**Request for Additional Information No. 378(4409, 4513, 4490), Revision 2
Supplement 3**

U. S. EPR Standard Design Certification

Docket No. 52-020

**QUESTIONS for Containment and Ventilation Branch 1 (AP1000/EPR Projects)
(SPCV)**

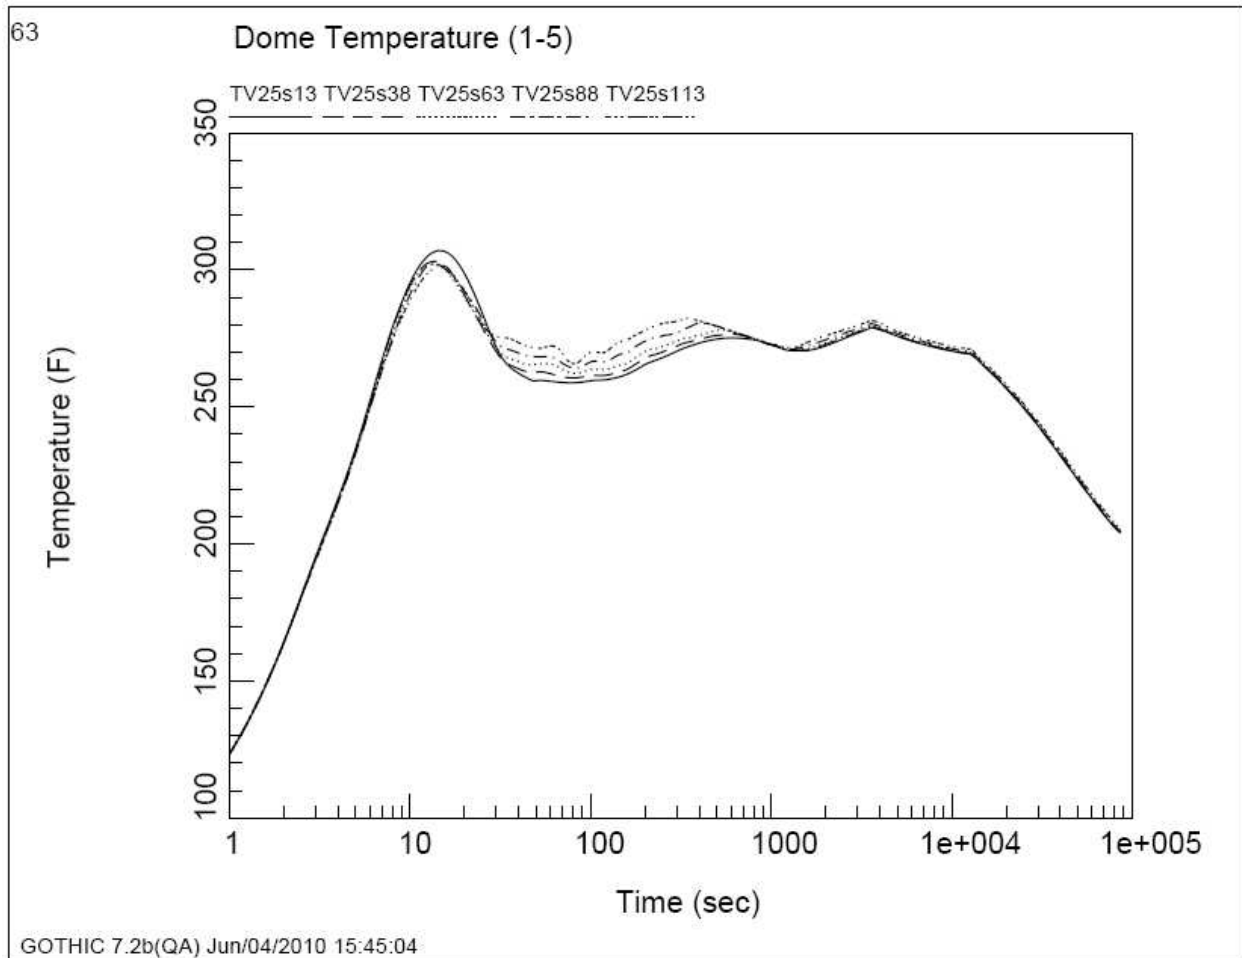
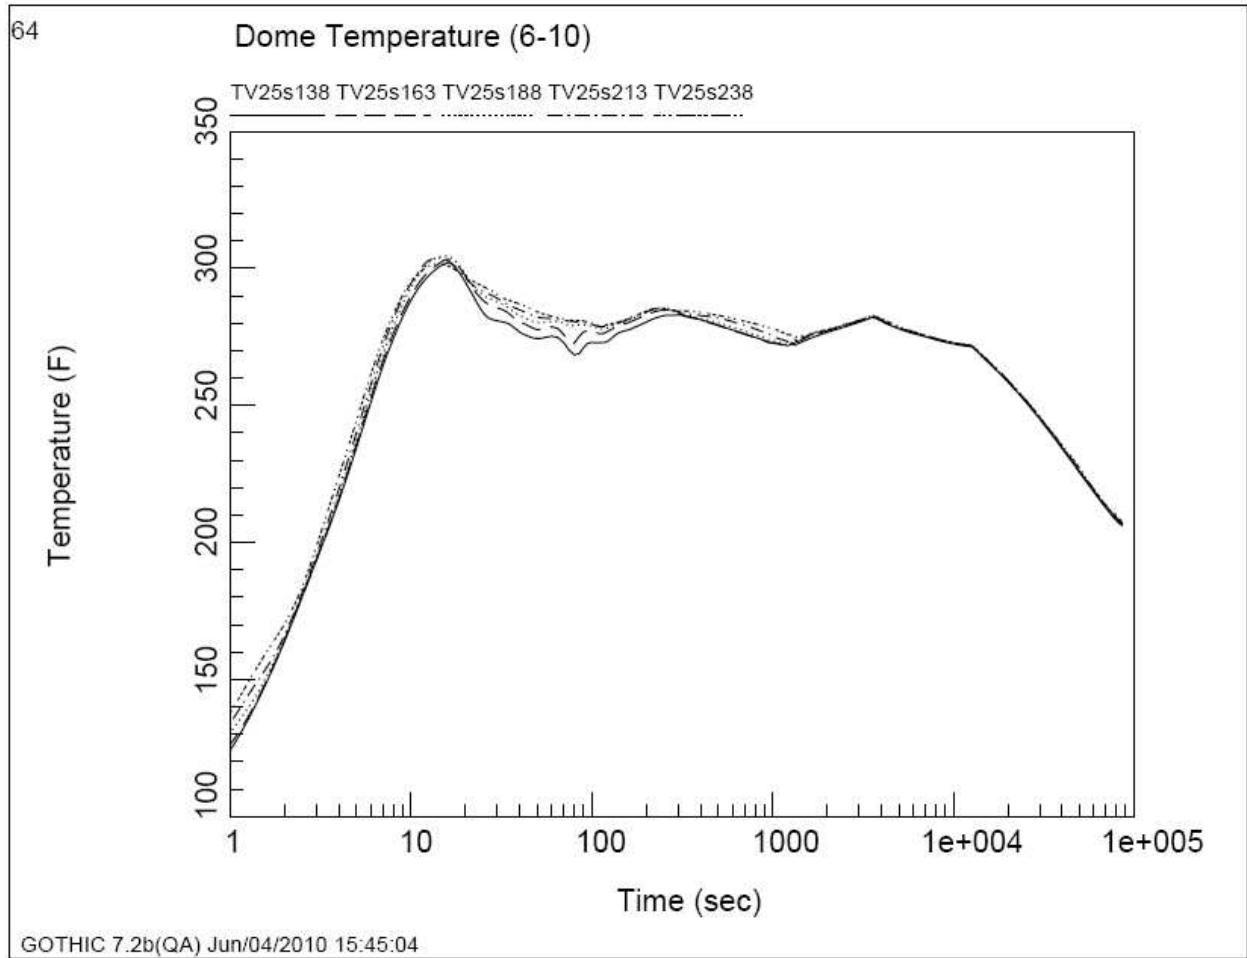
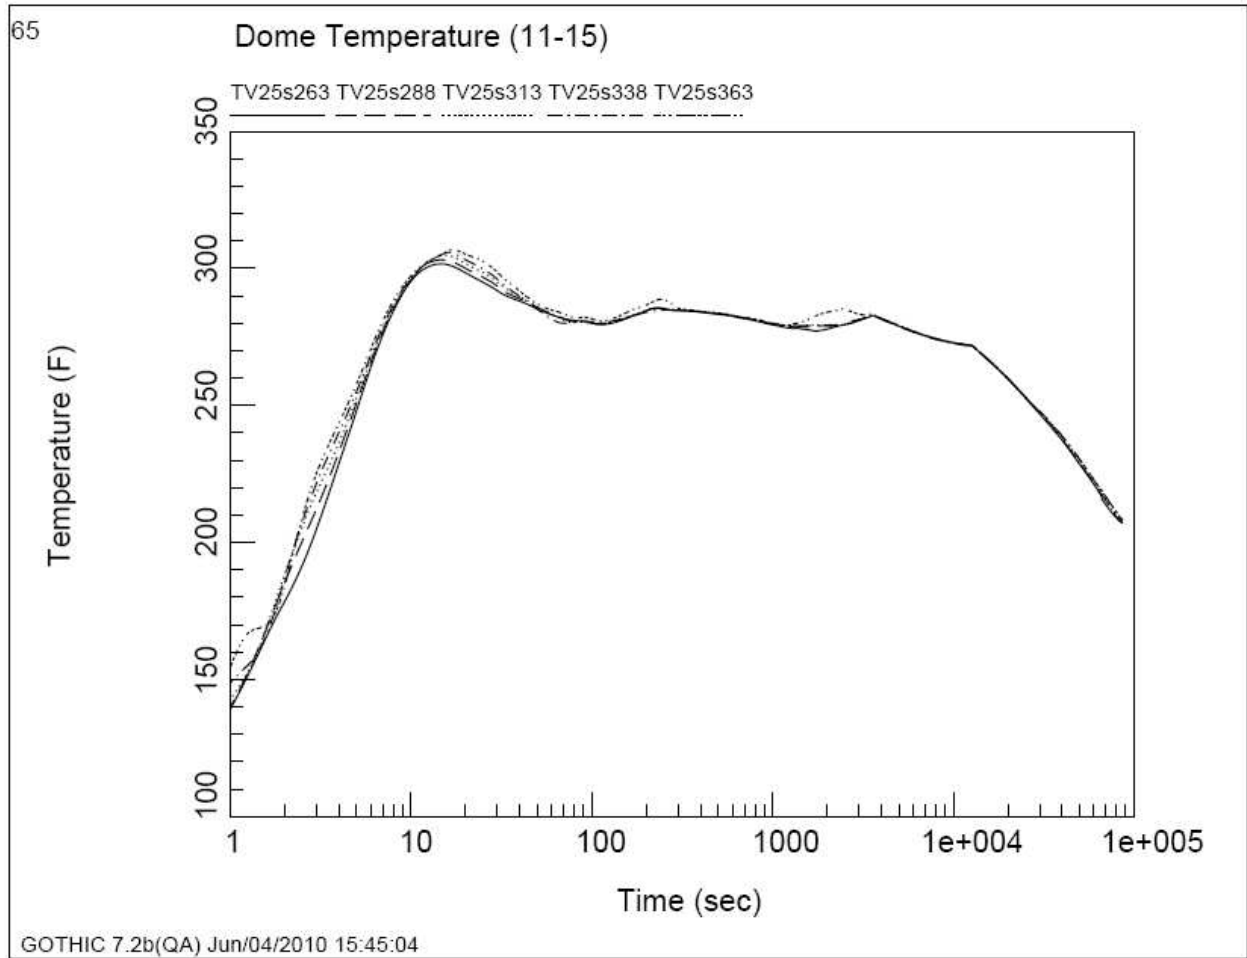
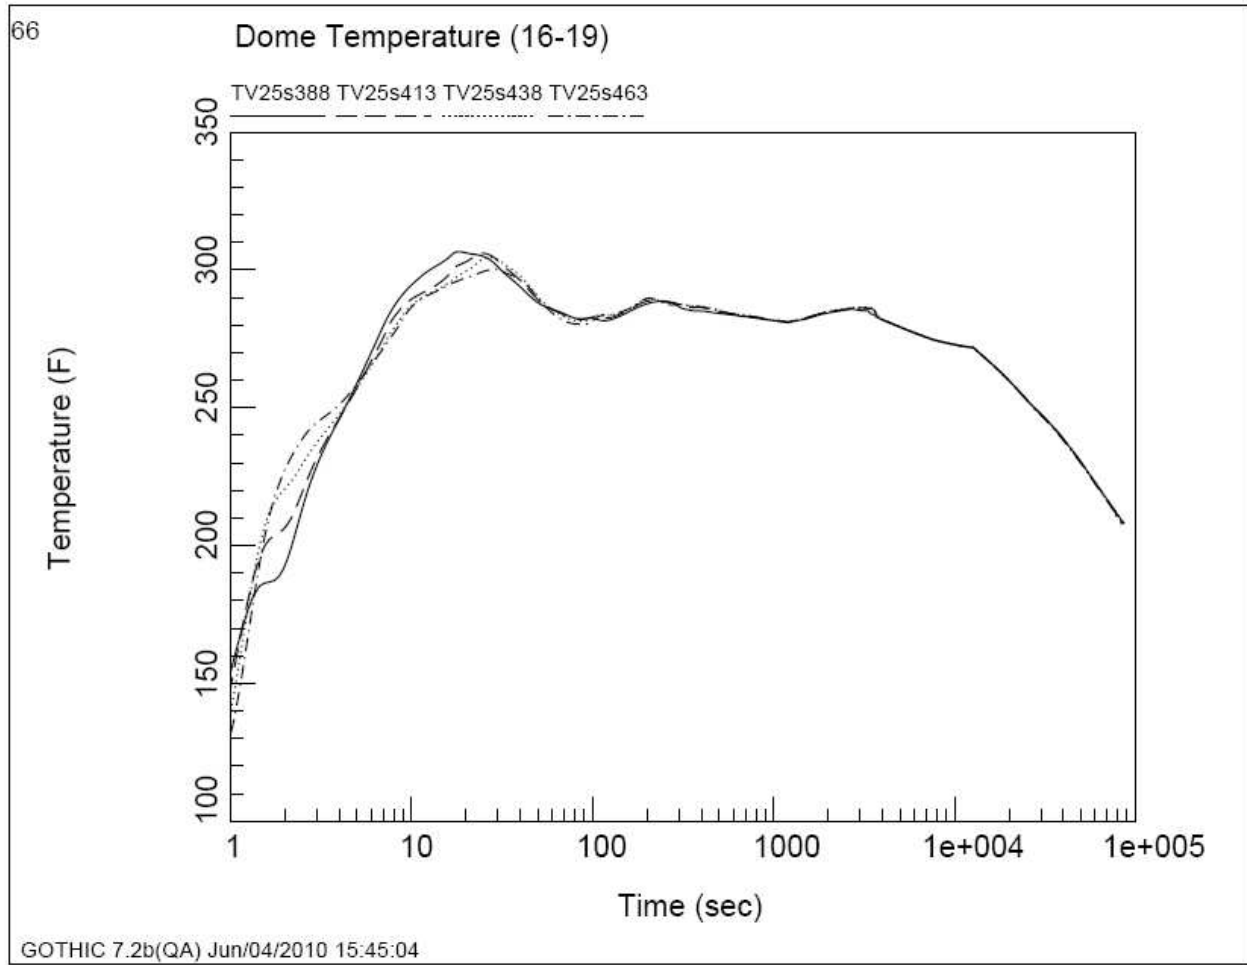
- a. Location of the maximum temperature reported in the FSAR (elevation and sub- divided node or lumped parameter node).
- b. Time history plots for atmospheric temperatures in the sub-divided dome (at elevations along the containment centerline, (19 elevations). Use the same time scale as the FSAR.
- c. Time history plots for atmospheric temperature below the dome (lump parameter nodes 1-30, excluding sub-divided dome region). Use the same time scale as the FSAR.
- d. Time history plots for gas velocity in pathways (FP #31 and 53 – rupture foils; FP# 11 and 12 – IRWST dampers; FP# 74 and 82 – middle annulus to dome; FP# 115 and 123 – upper annulus to dome). Use the same time scale as the FSAR.

- a) The temperature reported in U.S. EPR FSAR Tier 2, Figure 6.2.1-17 is the vapor temperature in the room that contains the break (equipment room – lumped parameter node #10).
- b) Figure 06.02.01-88-1 through Figure 06.02.01-88-4 show the time history atmospheric temperature for the sub-divided dome region. The temperatures are taken along the containment centerline. The plots are divided based on elevation, with Level 1 at the bottom of the dome and Level 19 at the top.
- c) Figure 06.02.01-88-5 through Figure 06.02.01-88-10 show the time history atmospheric temperature for volumes below the dome region (lumped parameter nodes one through 30, excluding the sub-divided node region).
- d) Figure 06.02.01-88-11 through Figure 06.02.01-88-14 show the time history gas velocity for the requested pathways.
